## Addendum No. 2

**Project:** 2017 Renovations  
**Manchester Elementary**  
Aurora, Indiana

**Proj. No:** 1649.02

**Date:** November 13, 2017

**Addendum 2  
Basebid Demolition Plan**

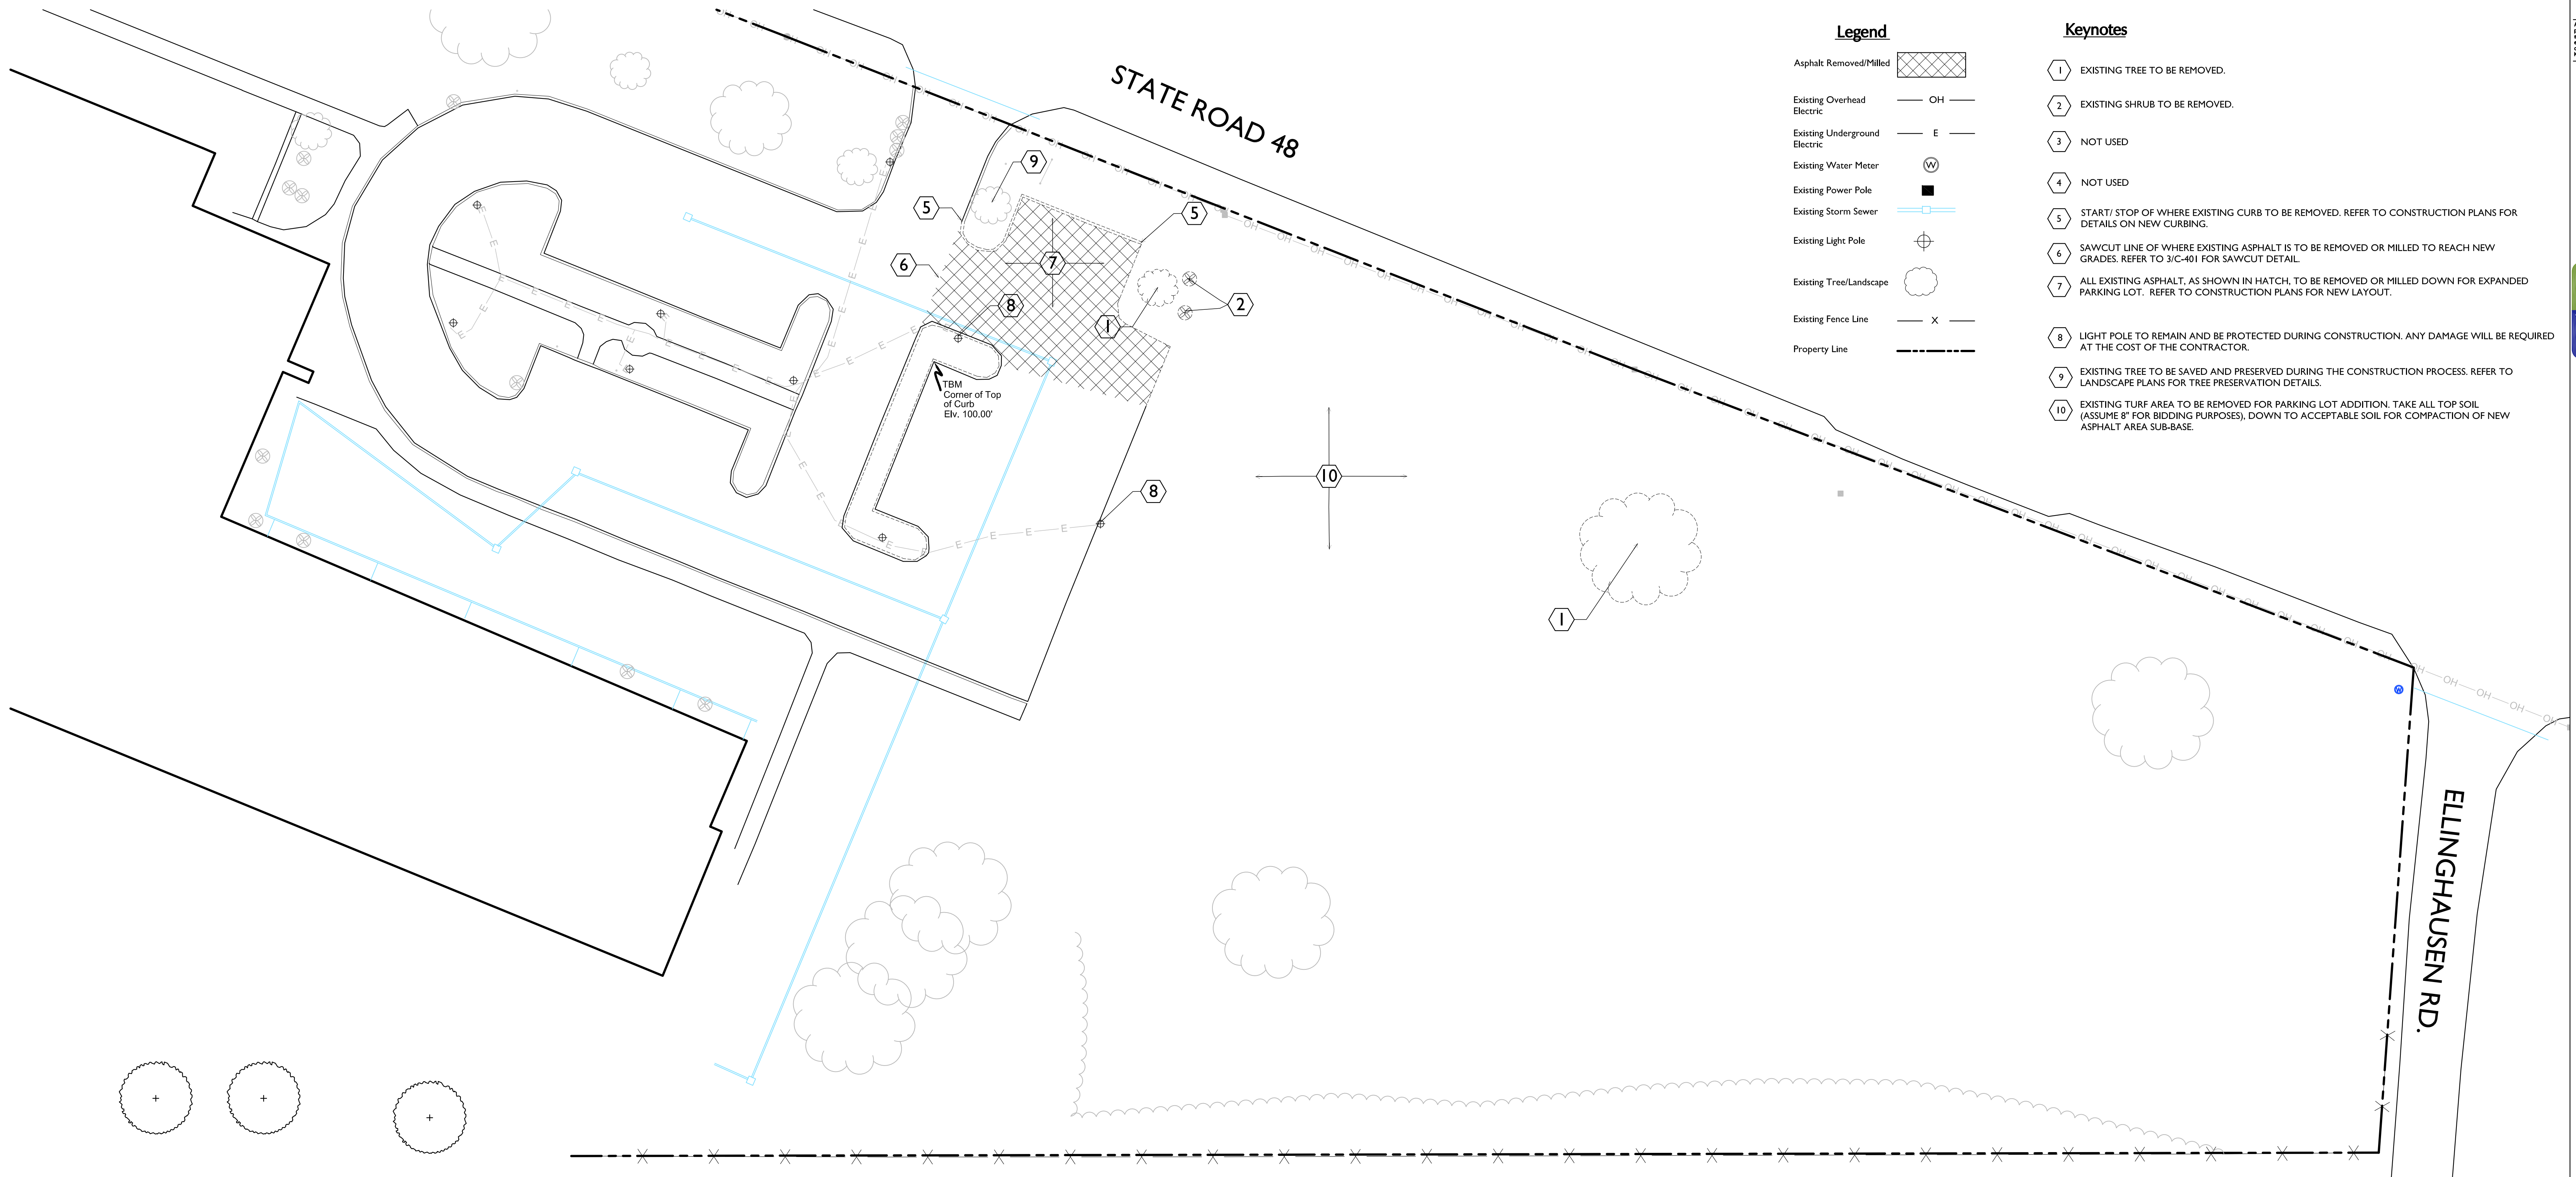
1. Drawing C-001  
Drawing AD-2f shall replace this drawing as the Base Bid. The original C-001 shall be used as basis for Alternate 8.
2. Drawing C-101

Addendum 2  
Basebid Site Development Plan

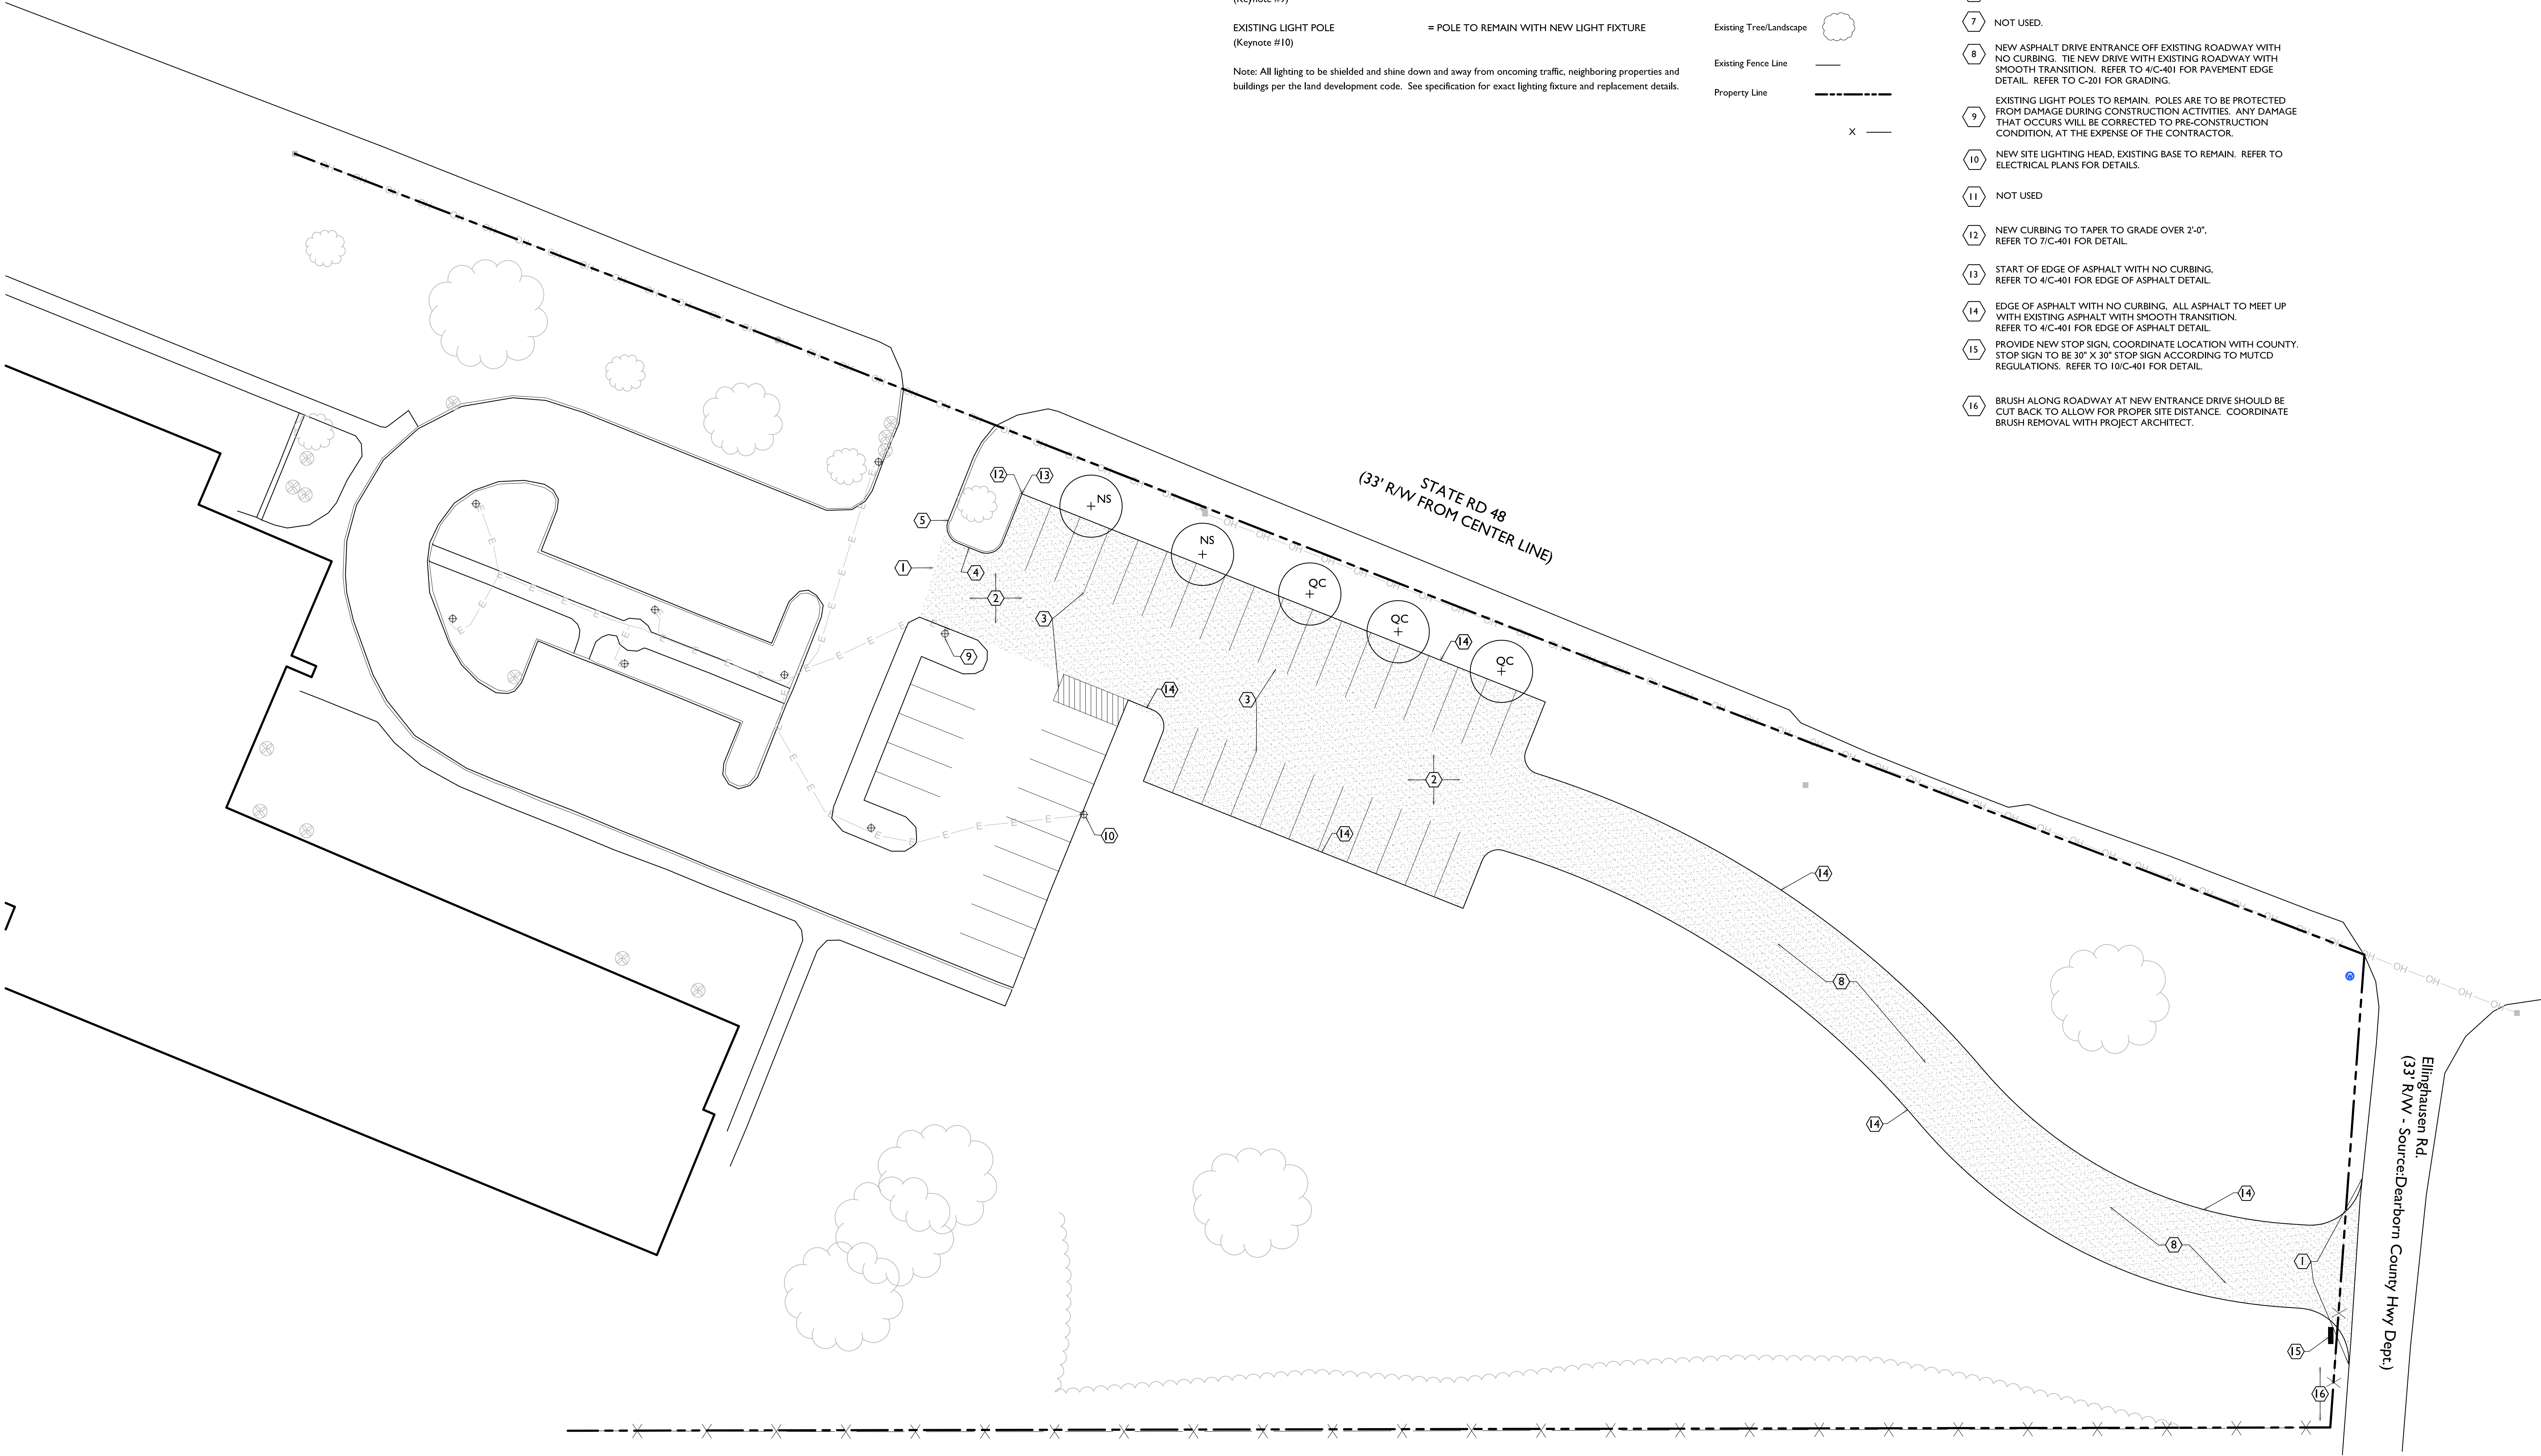
Drawing AD-2g shall replace this drawing as the Base Bid. The original C-101 shall be used as basis for Alternate 8.
3. Drawing C-102  
Drawing AD-2h shall replace this drawing as the Base Bid. The original C-102 shall be used as basis for Alternate 8.
